General Offices . Selden Street, Berlin, Connecticut

Docket No. 50-423 B11180

Millstone Nuclear Power Station, Unit No. 3 Summary/Submittal of Revised Responses to PSB Mechanical Series Questions

Status of PSB Mechanical Requests for Additional Information

FIGURE Q 430.73-4 PIPING CLASSES OF THE AIR START SYSTEM MILLSTONE NUCLEAR POWER STATION UNIT 3 FINAL SAFETY ANALYSIS REPORT

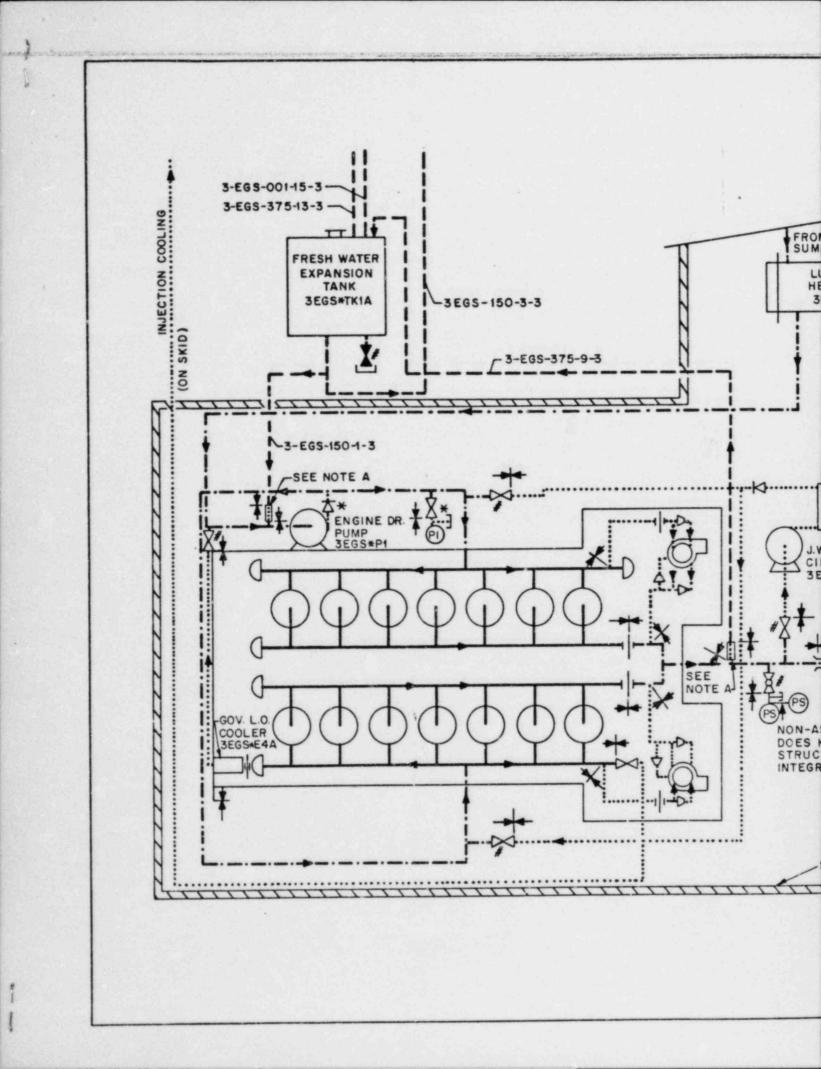
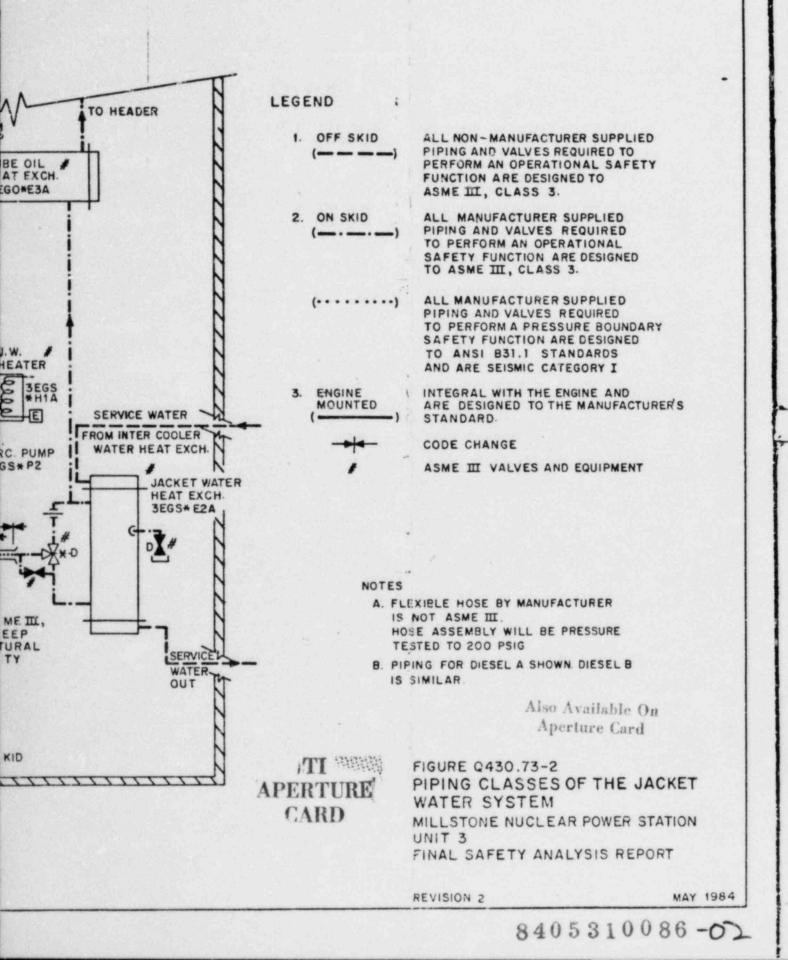
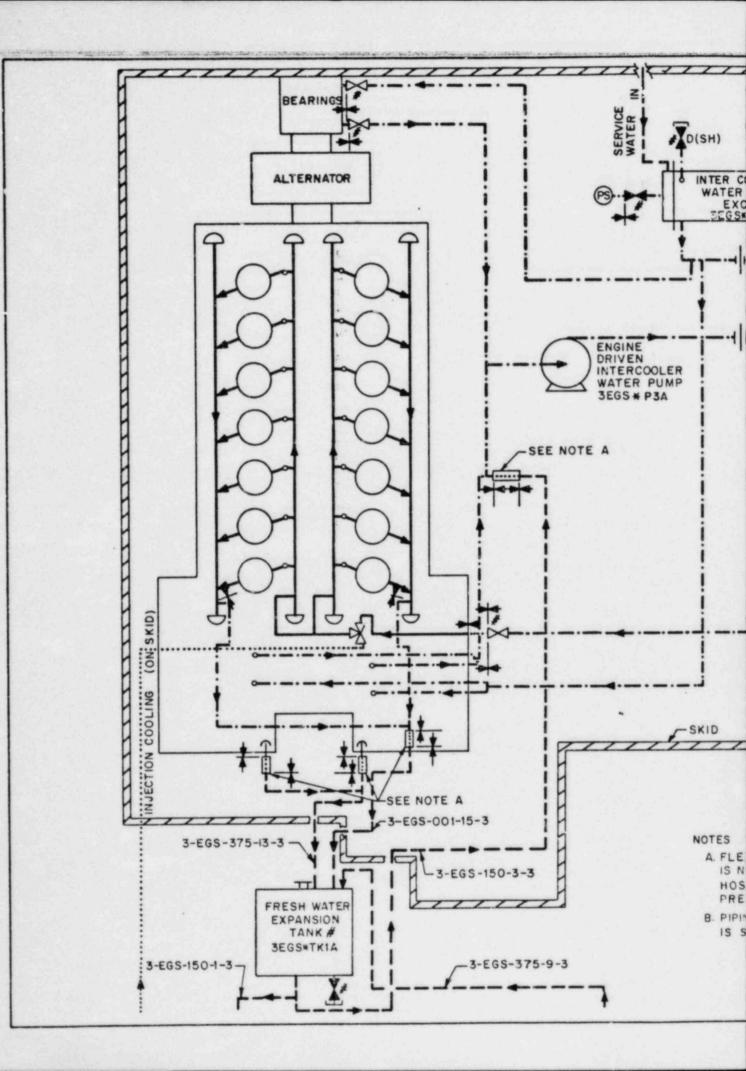
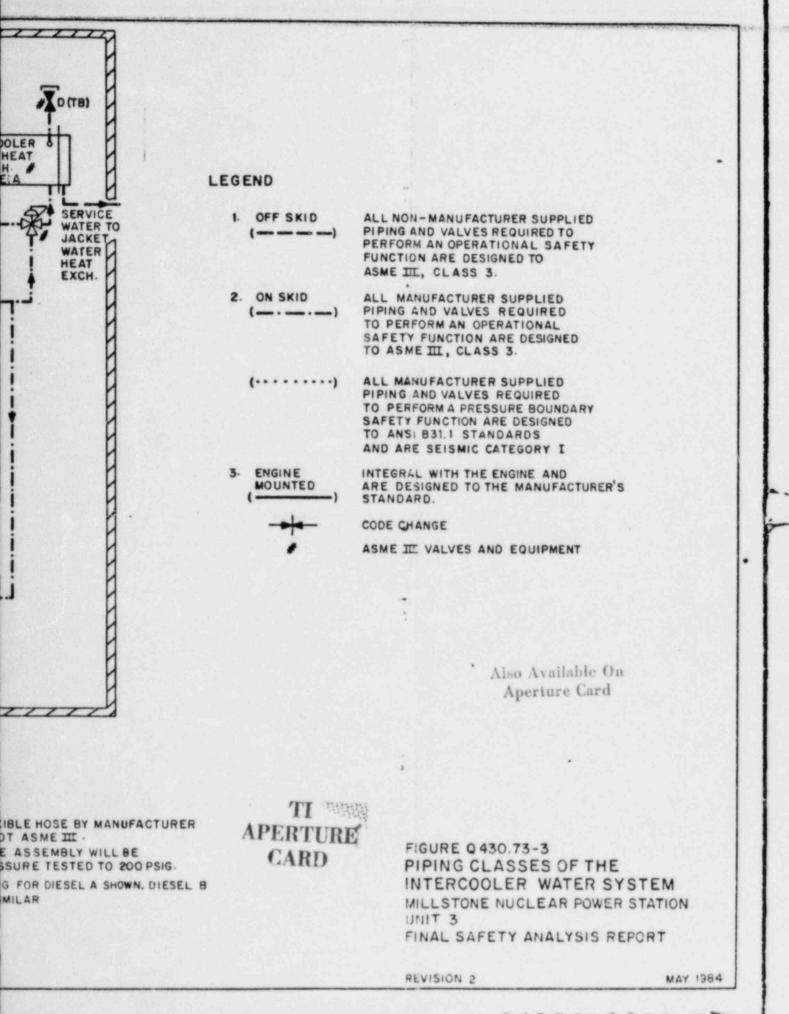
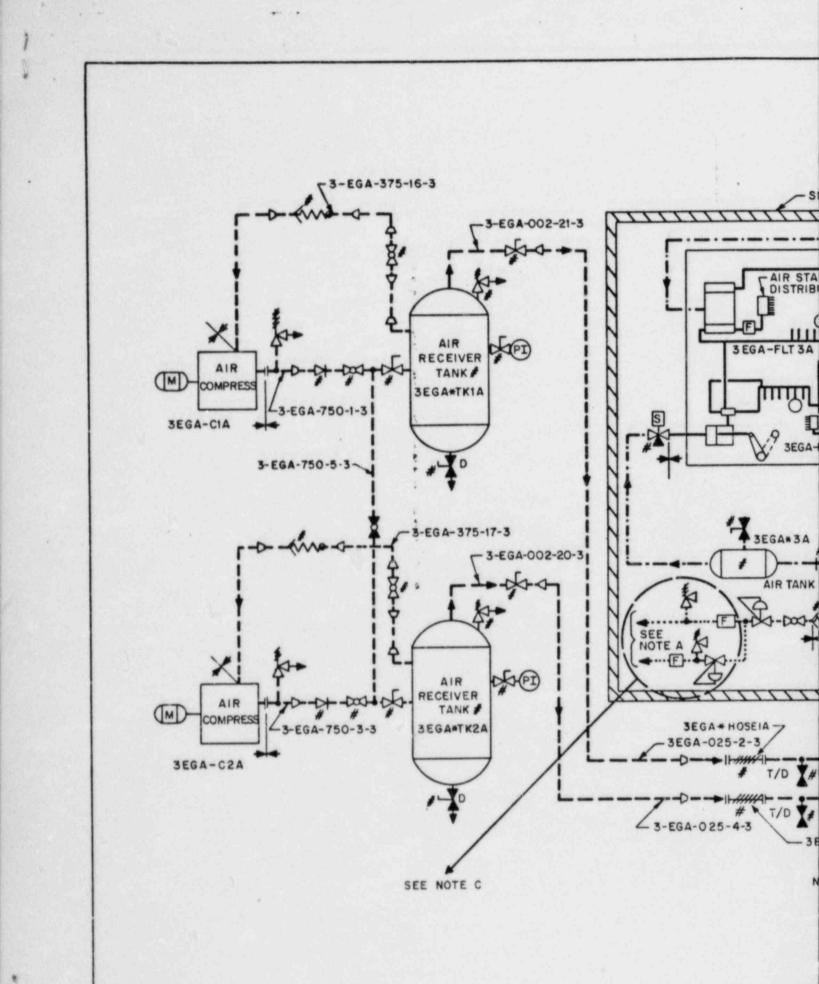
Question 430.73 (Section 3.2, 9.5.4, 9.5.5, 9.5.6, 9.5.7, and 9.5.8)

FSAR FiguresQ430.73-1 through 430.73-4 show the on skid and off skid portions of piping systems and components. All piping and components are designed to seismic and Category I requirements. As can be seen from FSAR Figures Q430.73-1 through Q430.73-4, the piping up to the diesel skid interface is ASME 3, Class 3 for all auxiliary piping. The majority of on skid and engine piping is also ASME 3. Class piping that is not ASME 3, Class 3 is designed to manufacturers standards. The manufacturers standards are listed in Tables 12 and 9.5-13 930 73-7*
